Whale Rock Intake Valve Replacement Project

Specification No. 90252a

ADDENDUM

ADDENDUM NO.: 1

GENERAL ARRANGEMENT
CYLINDER OPERATED RUBBER SEAT BUTTERFLY VALVE
WITH LOCKING LEVER FOR SUBMERSIBLE SERVICE

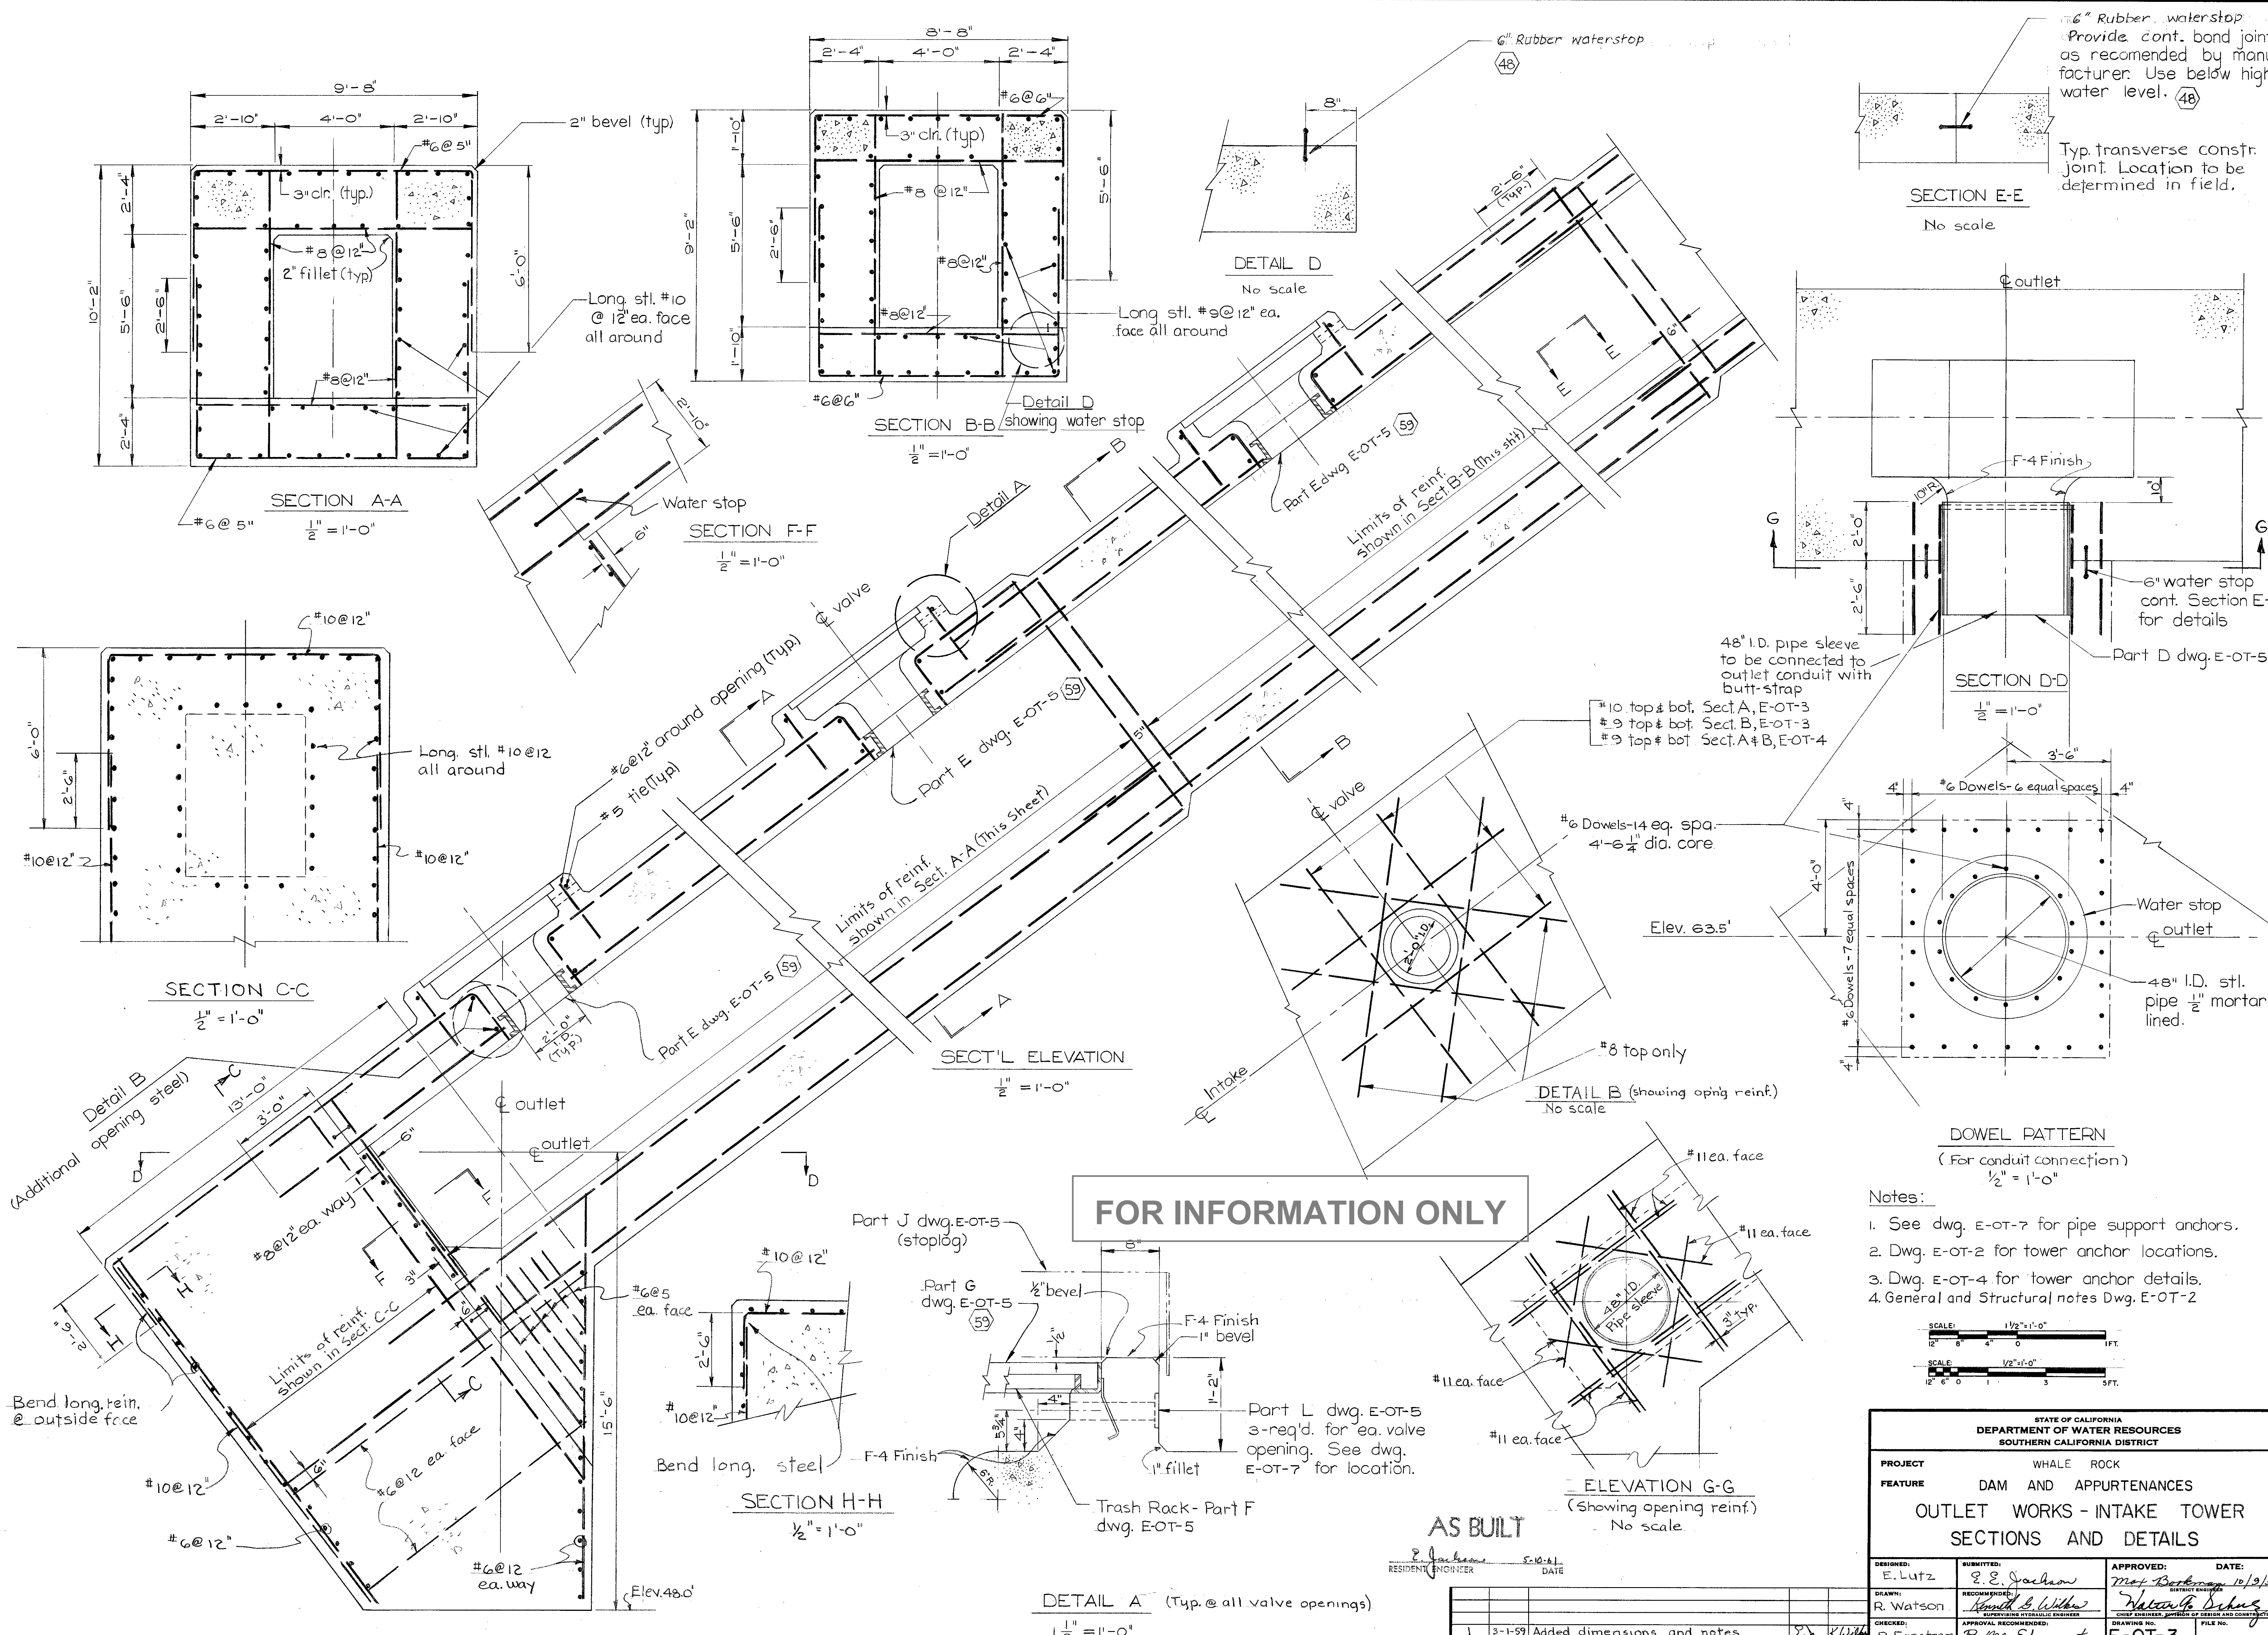
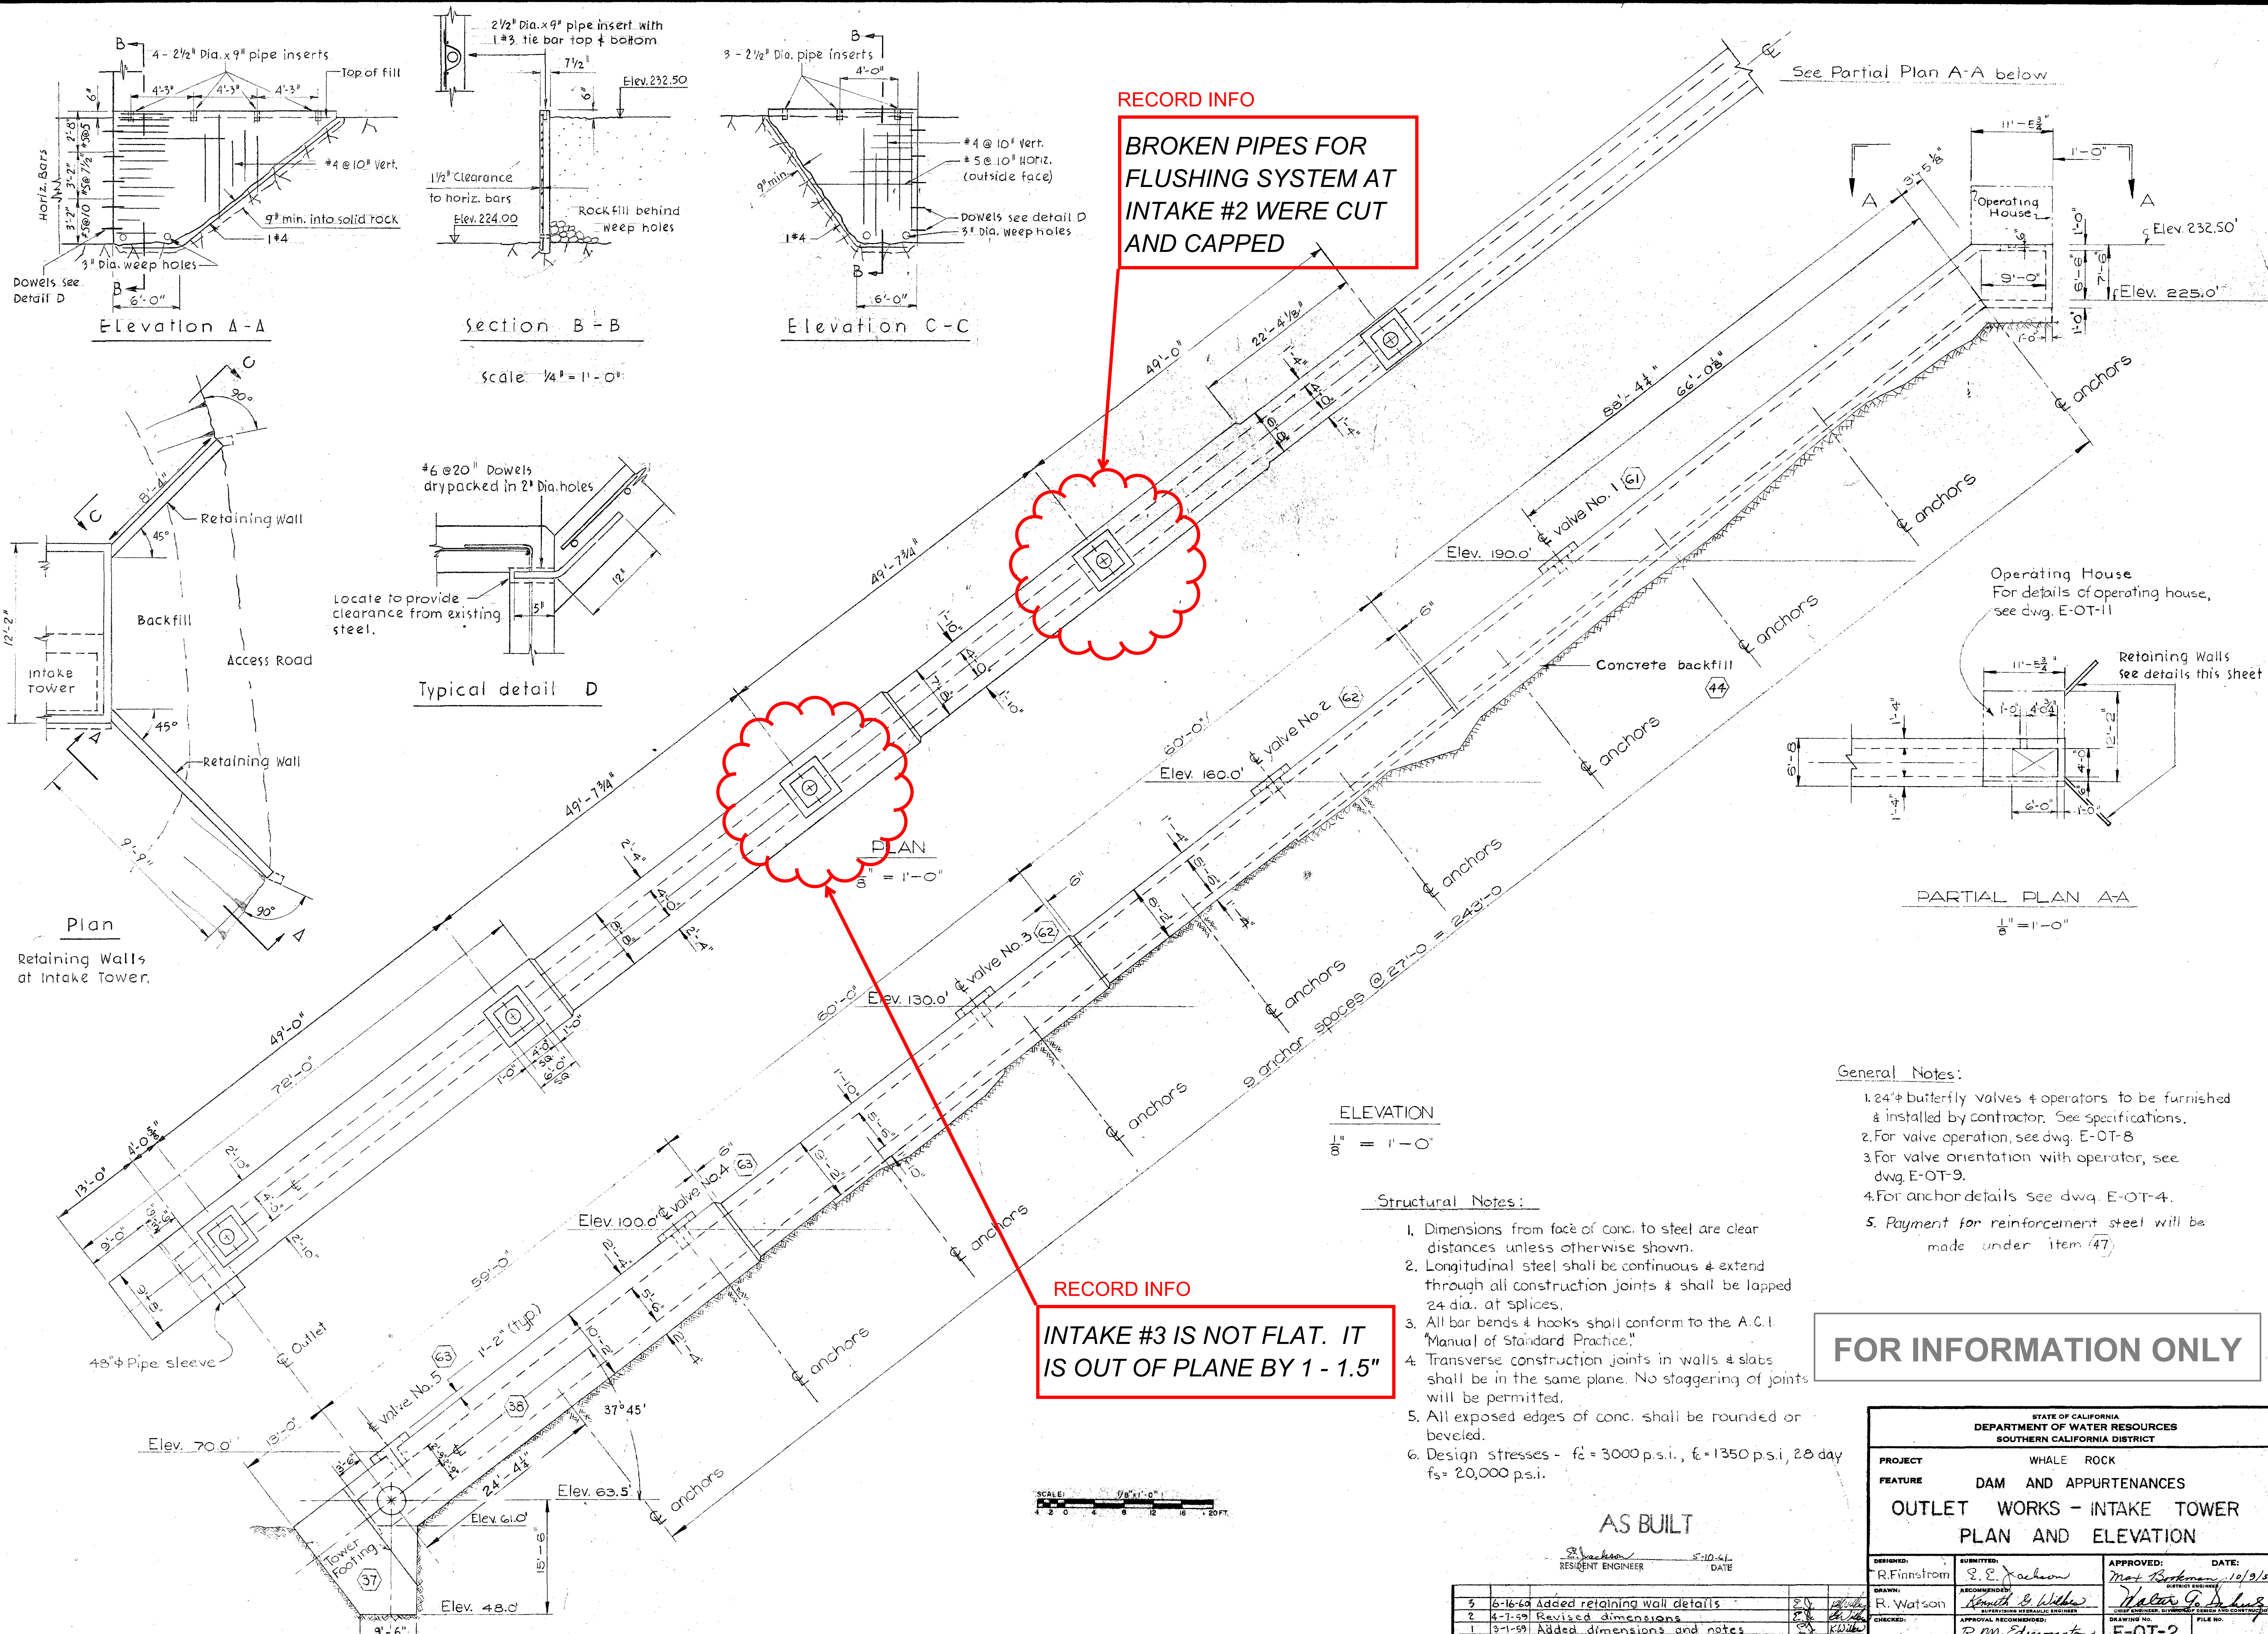
Valves. The spools to which the valves attach are cast with the bottom face of the flange flush with the ceiling of the intake tower. The flange is drilled and tapped, with studs threaded into the holes. The valves are attached to the studs with nuts as indicated on the plans. Standard 24" AWWA C504 Butterfly Valves will not work, due to four of the holes being tapped as a result of clearance restrictions. The valves that were originally installed are "long-body" valves, which allow sufficient clearance for all of the holes to fit cleanly over the existing studs. A standard valve and spool piece may work, though the City's preference is for the long-body valves. Contractors shall submit bids for long-body valves that will allow for "through bolting" of all 20 holes. If the cost is substantially less, Contractors may include an alternate price for standard valves and spool pieces along with their bid for the long-body valves. The City will decide, at its sole discretion, whether to allow standard valves and spool pieces.

The specification is further amended to eliminate the requirement that the valves have a rubber lined body. The valves shall have a seat that can be replaced in the field. Valves shall be AWWA Class 150B, Cast Iron body, cast or ductile iron disc, 316 stainless steel edge, 304 stainless steel shaft, Buna N seat, epoxy coated disc, epoxy coated or rubber lined body (Henry Pratt, K-Flo, or owner approved equal).

Actuators. The actuators specified are not recommended for continuous submergence. They are also pneumatic, rather than the required hydraulic actuation. The specification is amended to require that the new actuators shall be all stainless units approved for continuous submergence, with special piston seals specifically designed for water supply actuation. In addition, all adapting hardware necessary to mount the actuators to the valves shall be stainless steel.

The valve actuator shall be sized for operational loads based on full differential head pressure, using a full lake water level and dry on the back side of the valve. Flow velocities and dynamic torque shall be calculated by the valve manufacturer and used for sizing of the actuators. A de-clutchable manual gear override shall be included as an integral part of the valve actuator. The override shall allow for full valve operation by one person using the same dynamic torque loads as above. The manual override shall be such that the valve can be placed back into automatic operation without disassembly of the actuator. The actuator shall be rated for full water submerged service to the water depths shown on the drawings for each valve location. The actuator shall be Morin stainless steel S-Series with manual de-clutchable override or approved equal. The actuator shall fit into the required space as shown on the drawings and shall be rated for full submergence. Actuator sizing calculations shall be submitted for review showing dynamic torque loads and actuator output.
